Application Number 07/2018/4782/FUL

Address Land At
Butlers Farm Court
Leyland
Lancashire

Development Erection of 6 apartments with associated car parking (Amended Plan)

Officer Recommendation Approval with Conditions

Location Plan

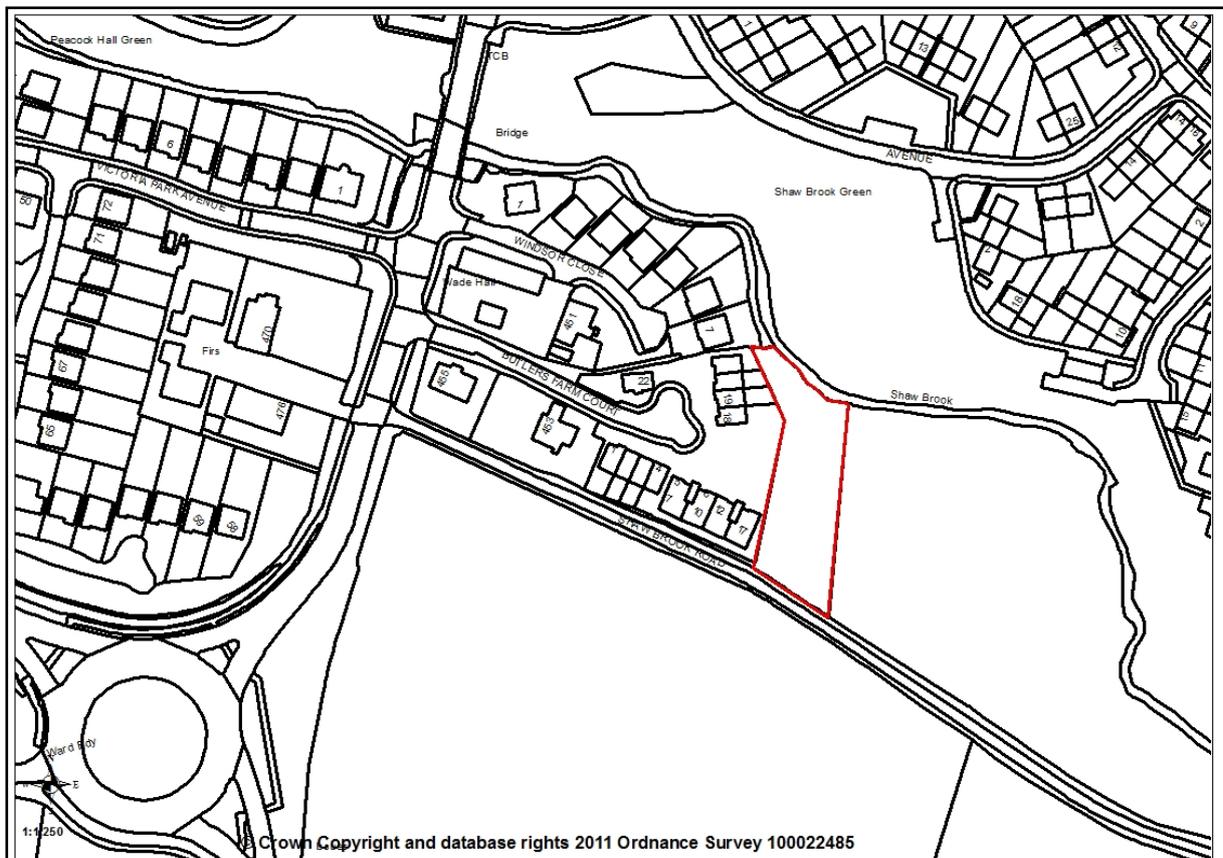
1.1 The application would normally fall for determination under delegated powers but the ward councillor has called it to planning committee for determination following contact by a local resident who has concerns over the development.

1.2 The application proposes the erection of six apartments in a three storey block located adjacent an existing apartment block. Access would be through the existing car park serving the apartments, extending the road and creating additional car parking spaces. No objections have been received from County Highways.

1.3 The site is located close to Shaw Brook in an area designated as Flood Zone 2 and 3; Bank Top Buffer Zone and contaminated Land. The Environment Agency initially objected as some development was within the buffer zone but following the submission of amended site layout plan, they withdrew their objection. Consequently there are no statutory objections to the proposal.
